**DESIGN REVIEW BOARD AGENDA
NOTICE OF MEETING**

TITLE: <p style="text-align: center;">DESIGN REVIEW FILE: DESIGN-2023-30-OCTOBER-6A 19 RICHMOND STREET (PID #339739) OWNER: 103040 PEI INC. (JACKIE AND PHILIP O'HALLORAN)</p>		
MEETING DATE: October 30, 2023		Page 1 of 5
DEPARTMENT: Planning & Heritage	ATTACHMENTS: <ul style="list-style-type: none"> A. Design Review Original Submission (June 27, 2023) B. External Design Reviewer Comments (August 8, 2023) C. Revised Design Reviewer Submission (September 12, 2023) D. Final Design Submission (October 24, 2023) 	
SITE INFORMATION: Ward No: 1 Queens Square Existing Land Use: Vacant lot previously occupied by Irwin Printing Official Plan: Downtown Neighbourhood Zoning: Downtown Neighbourhood Zone (DN)

TITLE: DESIGN REVIEW FILE: DESIGN-2023-30-OCTOBER-6B 199 GRAFTON STREET/156 PRINCE STREET (PID #342790) OWNER: 102390 PEI INC. APPLICANT: APM COMMERCIAL ROYAL LEPAGE		 CHARLOTTETOWN	
MEETING DATE: October 30, 2023		Page 1 of 7	
DEPARTMENT: Planning & Heritage		ATTACHMENTS: A. Design Review Submission Including Rationale Paper (August 25, 2023) B. External Design Reviewer Comments (October 26, 2023) C. Design Review Submission (February 21,

1 SOUTH ELEVATION
A-9 1/16" = 1'-0"

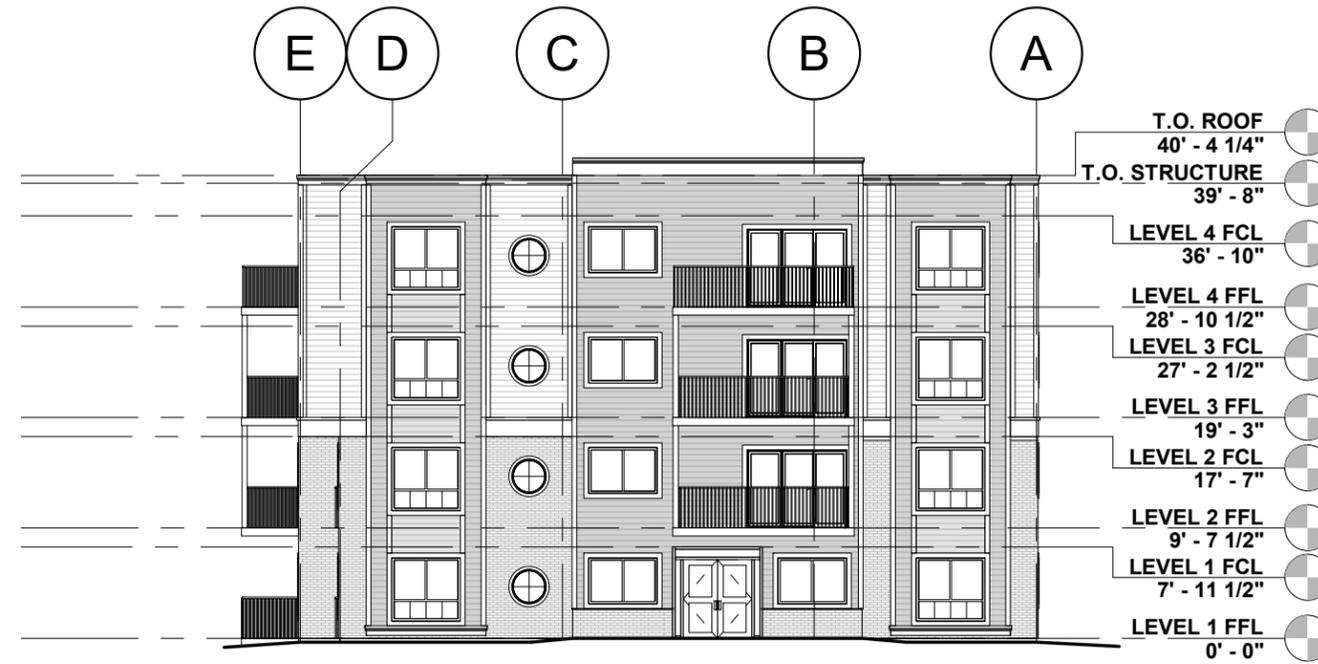
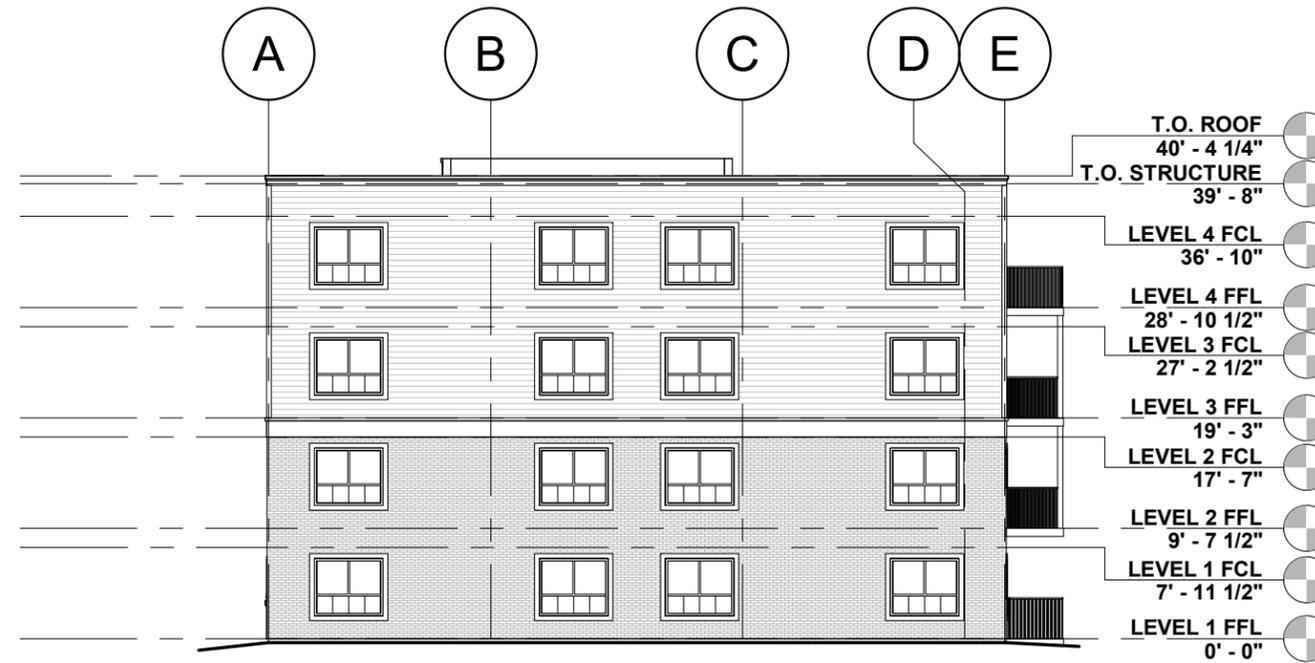
RECOMMENDATIONS: According to 7.5.4 of the Zoning and Development Bylaws, sliding doors are not permitted on the front façade of a building within the 500 Lot area. Therefore, these will not be acceptable as presented in the South Elevation, but what is portrayed in the 3D imagery is permitted. Please clarify that the French door option will be installed.

After receiving comments from the design reviewer, staff forwarded Mr. Munn's report to the applicants and their architect. Both the applicants and their architect agreed to the suggested changes and revised the drawings to incorporate the suggested changes by the design reviewer. The fourth storey was also stepped back to incorporate a 4 foot step-back along the front façade as per Attachment C. The revised drawings were sent back to the design reviewer and it was suggested by the reviewer that a 4 foot step-back was not adequate to hide the fourth storey from adjacent buildings when viewed from the centerline of the street as per the following comments,

1
A-9
DR SOUTH ELEVATION
1/16" = 1'-0"

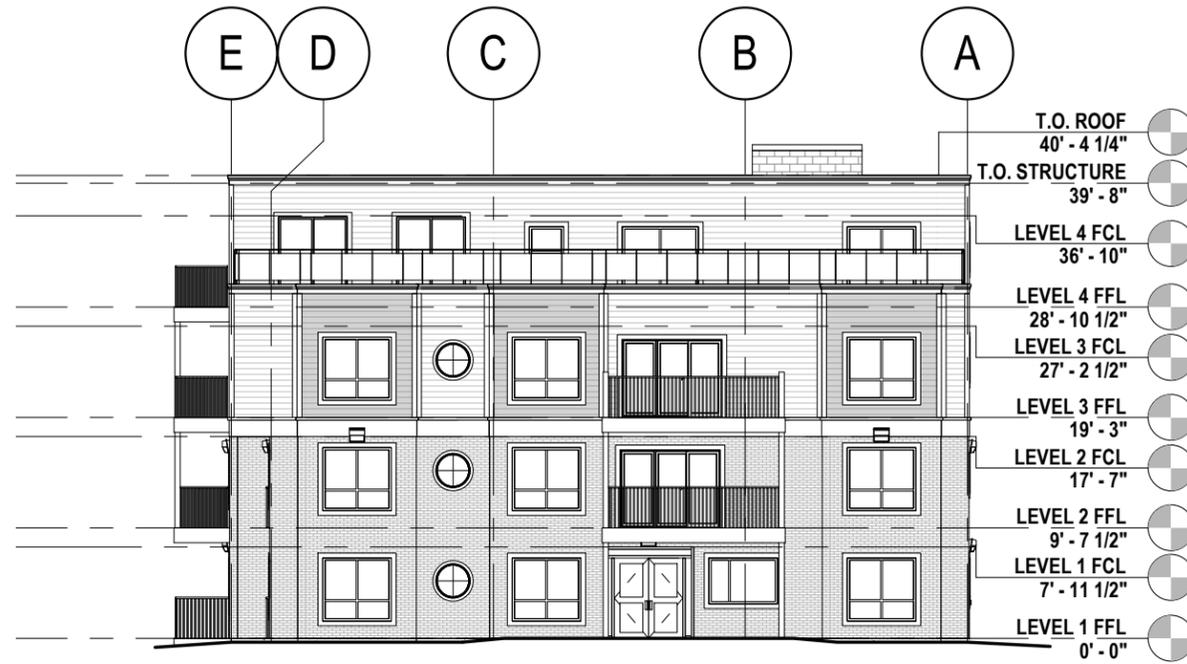
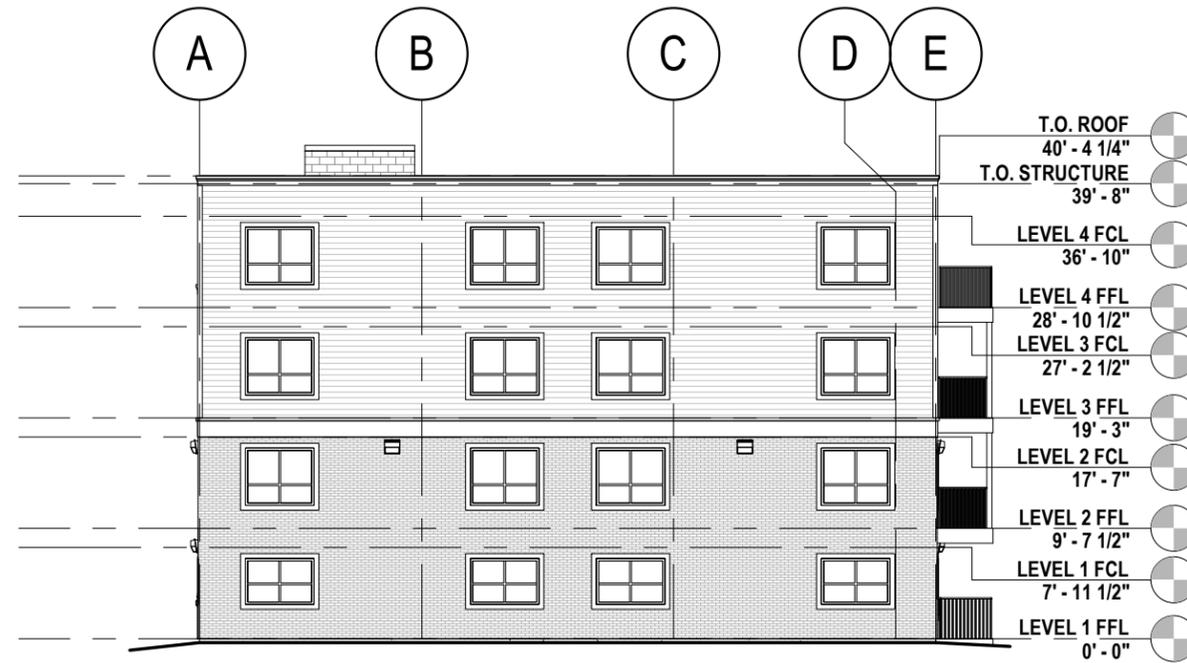
"The scale and perceived height of the revised proposal feels right within the context of the neighbouring houses, and I am satisfied with the fourth floor stepback. I would recommend approval of this revised design."

Planning staff recommend that the Design Review Board approve the proposed revised building design submitted October 24, 2023 (Attachment D) for the four (4) storey, multi-unit development located at 19 Richmond Street (PID #339739).
